SUNDRY NOTICES AND REPORTS ON WELLS

PEARSALL QUEEN SAND UNIT

TRACT 1 WELL #1

PROPOSE TO PLUG AND ABANDON THIS WELL.

WELL: Pearsall Queen Sand Unit Tr 1 #1 LEASE No. LC-029403(A)

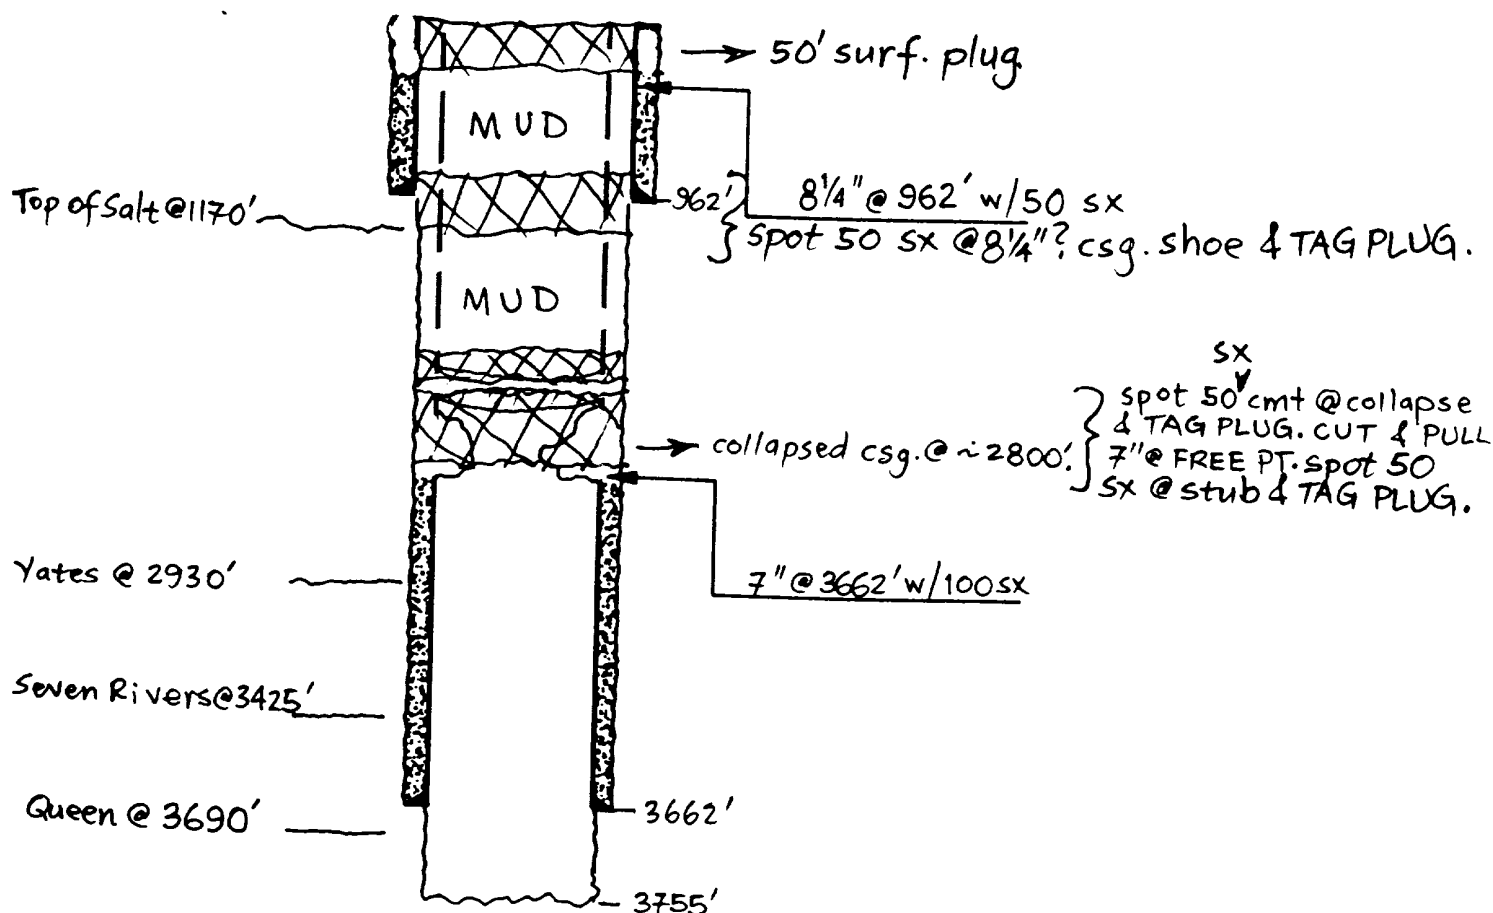
***NOTE:** Records on this well are somewhat questionable with regard to casing sizes and setting depths. BLM must exercise discretion at time of plugging to accommodate the inconsistencies. P&A plan as submitted should be sufficient regardless of csg. size or setting depth. (SJS)
